STAFF RECOMMENDATION
2201 25th Avenue South
October 16, 2013

Application: New construction-addition, Setback reduction
District: Hillsboro-West End Neighborhood Conservation Zoning Overlay
Council District: 18
Map and Parcel Number: 10415003200
Applicant: Tong Wang, owner
Project Lead: Robin Zeigler, robin.zeigler@nashville.gov

<p>Description of Project: The applicant proposes to construct a minimal one-story addition on to a non-contributing building located at the intersection of 2th Avenue South and Blair Boulevard.</p> <p>Recommendation Summary: Staff recommends approval of the addition and the rear setback reduction with the conditions that Staff review final details of windows and doors and that they HVAC be located towards the rear of the property, if a new location is necessary. Staff finds the project to meet the requirements for new construction in the Hillsboro-West End Neighborhood Conservation Zoning Overlay and the MHZC's policy for setback reductions.</p>	<p>Attachments A: Photographs B: Site Plan C: Elevations</p>
--	--

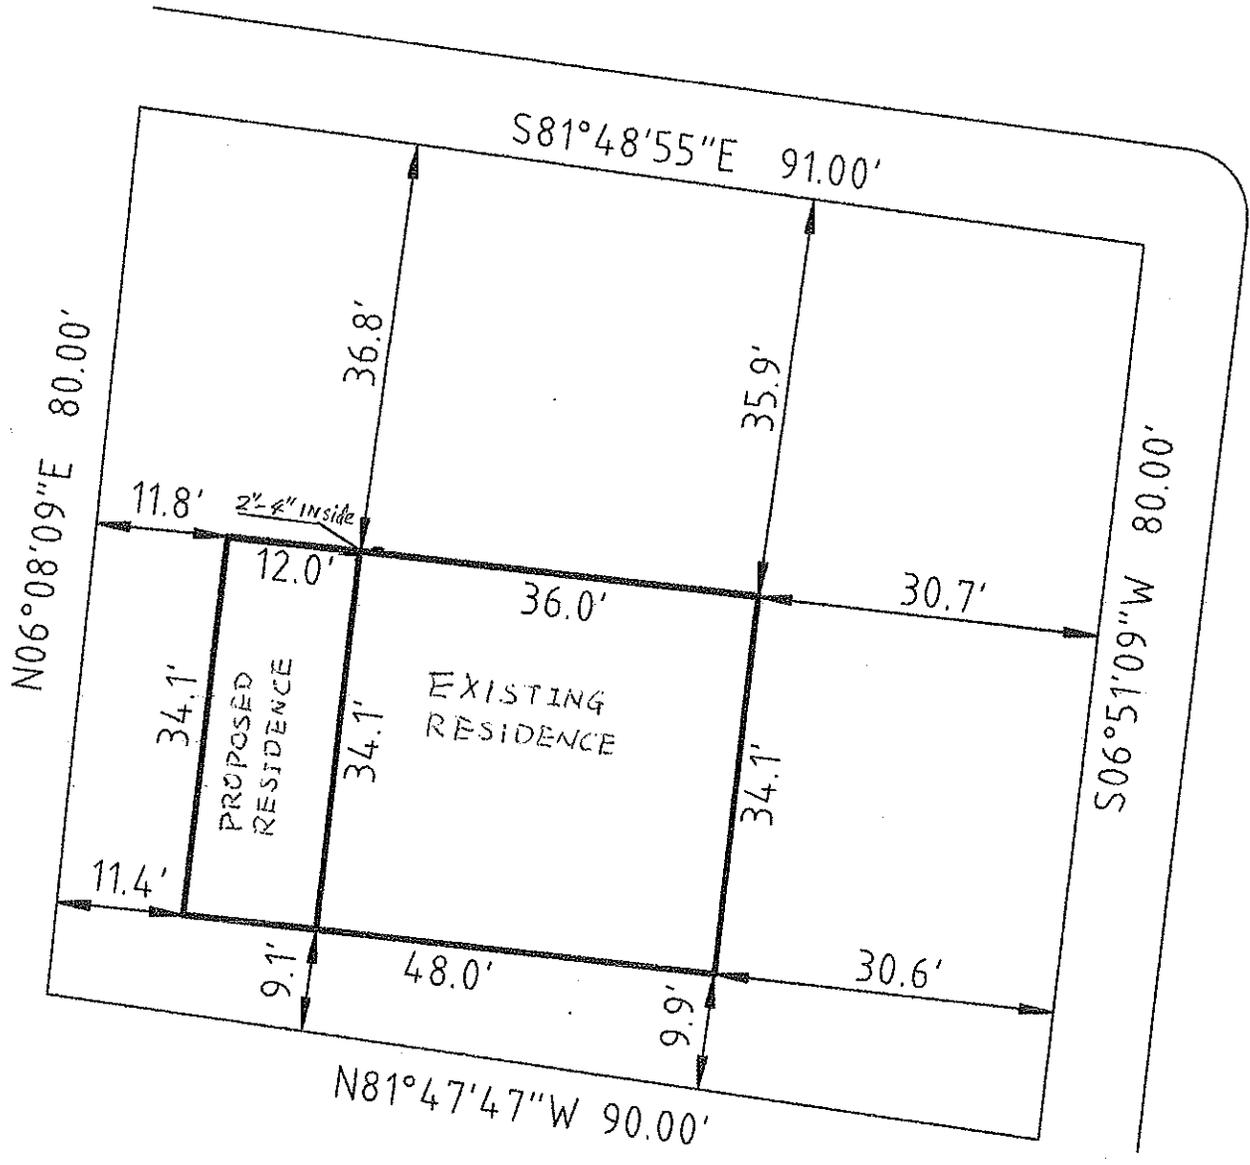
Setback & Rhythm of Spacing: The side setbacks are the same as the existing house and meet bulk standards. The rear setback is proposed to be twelve feet (12') where bulk zoning requires twenty feet (20'). The house is a non-contributing house oriented towards 25th Avenue South. If in the future it is demolished for a new house, the infill project will likely be required to be oriented towards Blair Boulevard, as all other lots at this intersection are. In that case, the side (currently rear) setback may be as little as five feet (5'). In addition, the new construction is minimal in size and massing and so it will have very little impact on the neighboring two-story non-contributing property. The setback is needed in this instance as there is no other appropriate location to add on to the small home and the addition requested is minimal. Staff finds that the setback reduction, in this instance, is appropriate and meets section II.B.1.c.

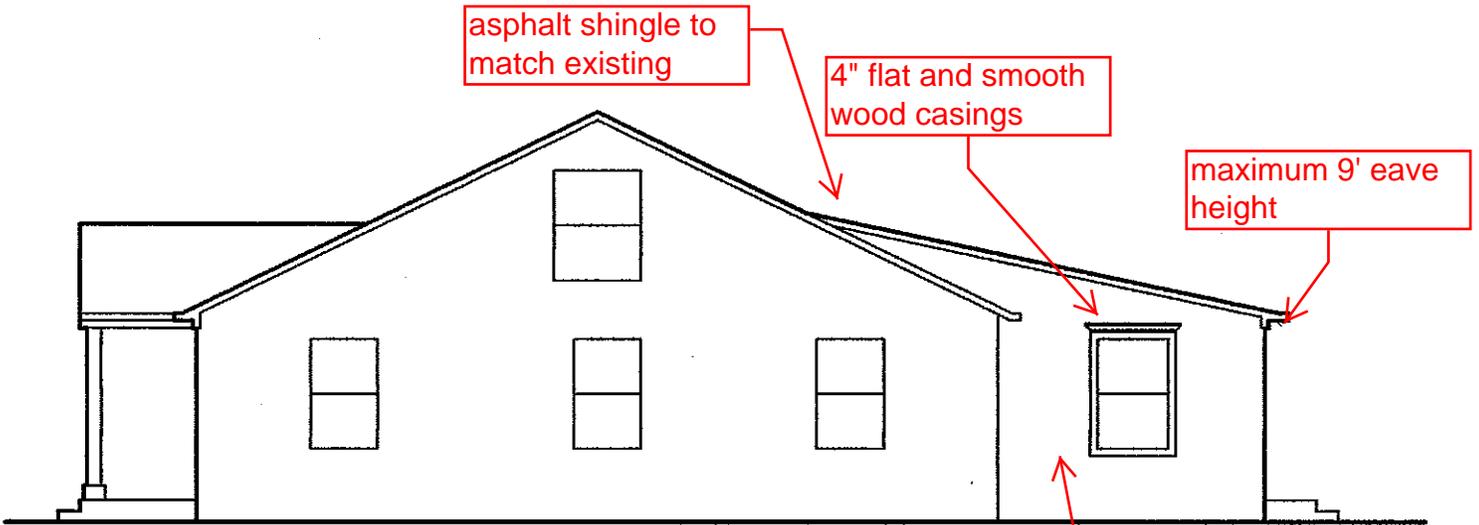
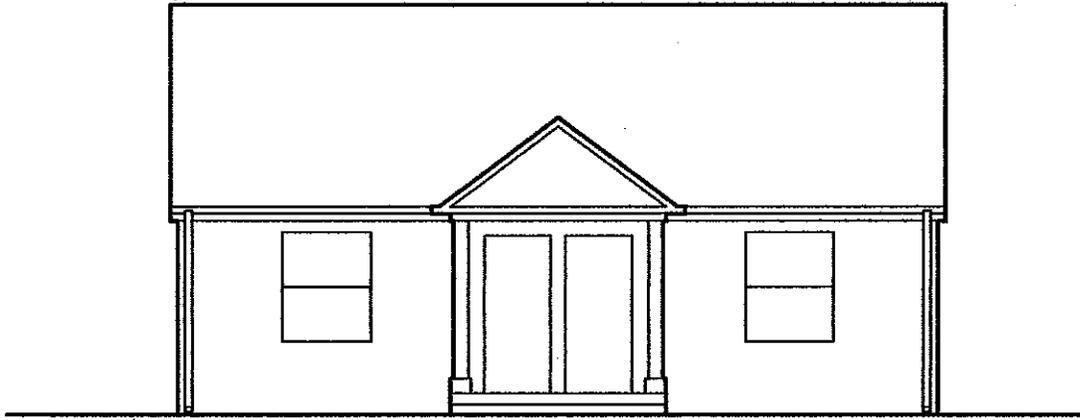
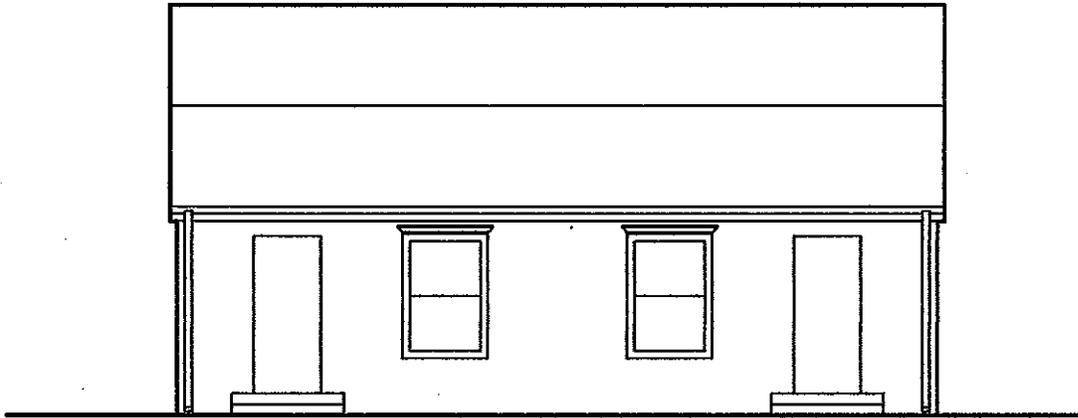
Height & Scale: The proposed addition is just 12' x 35' and is no taller and no wider than the existing building. Because of its low-profile, the project meets section II.B.1.a and b, as an appropriately scaled addition.

Design: The design is distinguished from the existing house with its materials and roofline. The project meets section II.B.2.a and f.

Materials: No major changes to the historic house's materials were indicated on the drawings. The addition will primarily be clad in smooth face cement fiberboard with a five inch (5") reveal. The trim will be wood. The foundation will be poured concrete, and the roof will be architectural fiberglass shingles in a color to match the existing roof. The windows and doors were not noted on the plans, and staff asks to approve the final window and door selections prior to purchase and installation. With the staff's final approval of the windows and doors, staff finds that the known materials meet Sections II.B.1.d

Roof form: The roof form will be a low sloped shed roof attached well below the ridge of the side-gable house, which is a typical form found in the district. The project meets section II.B.1.e.

Proportion and Rhythm of Openings: No changes to the window and door openings on the existing house were indicated on the plans. The windows on the proposed addition will be similar to the existing house. There are no large expanses of wall space without a window or door opening. Staff finds the project's proportion and rhythm of openings to meet Section II.B.1.g.

Staff recommends approval of the addition and the rear setback reduction with the conditions that Staff review final details of windows and doors and that they HVAC be located towards the rear of the property, if a new location is necessary. Staff finds the project to meet the requirements for new construction in the Hillsboro-West End
